PLANNING APPLICATIONS COMMITTEE 14 DECEMBER 2021
SECOND ADDENDUM: AMENDMENTS AND ADDITIONAL INFORMATION ON AGENDA ITEMS

<u>ITEM 3</u>		
Erection of a nine storey building comprising a commercial unit (Class E) at ground floor and basement level and 9 no. self-contained residential flats (Class C3) on the upper levels. 21/01864/FUL		
Page Number	Report Changes	Decision Letter Changes
19	<p>Add the following to the end of Paragraph 6.3.5:</p> <p>A further representation from the Waterloo Community Development Group was received, objecting to the proposal. The newly raised planning considerations are summarised below:</p> <ul style="list-style-type: none"> The £60,000 contribution towards the redevelopment of Emma Cons Gardens will have little impact in relation to the estimated £1m costing of the works, including around £60,000 annually for upkeep. <i>Officers' Comments: The contribution is considered to be of an acceptable scale to the proposed development.</i> The daylight and sunlight considerations have misunderstood the scale of the housing proposal on the adjoining car park site. <i>Officers' Comments: As mentioned within this report, there is no live application or pre-applic

TOWER ALIGNED TO AVENUE

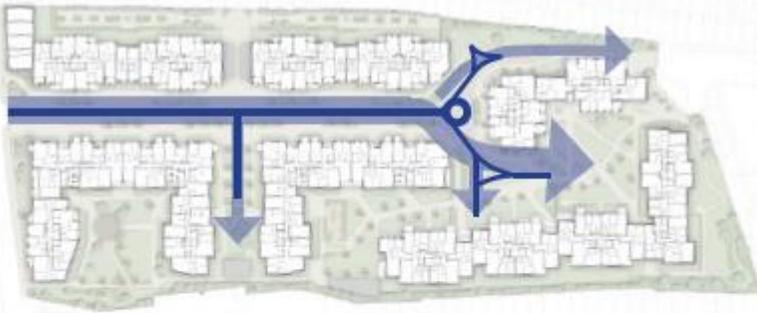
The Tower was considered to be a key element within the masterplan form and as such it was felt that in its proposed asymmetric position in relation to the street it was somewhat apologetic. It was agreed that the tower should be moved on axis to the main street as an appropriate terminus to this route. As a consequence, the strong symmetry of the tower is replicated in this location within the masterplan.

Center of Tower aligned to the centerline of the main avenue servicing the site. Block to South East of taller building redesigned to improve potential route to Pulross Centre and better define courtyard.

VIEW B - HIGH-RISE TOWER

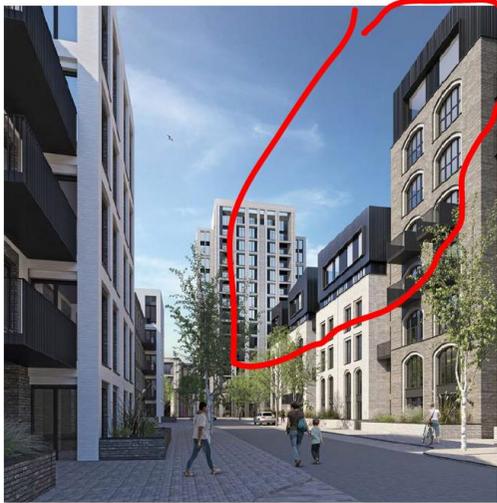
- In terms of detailed design, suggested simplifying the design in particular the roof form and that careful considered should be afforded to balcony type/character.

ESA Architecture Response: The roof form in question was simplified to reduce variation in angle / pitch.
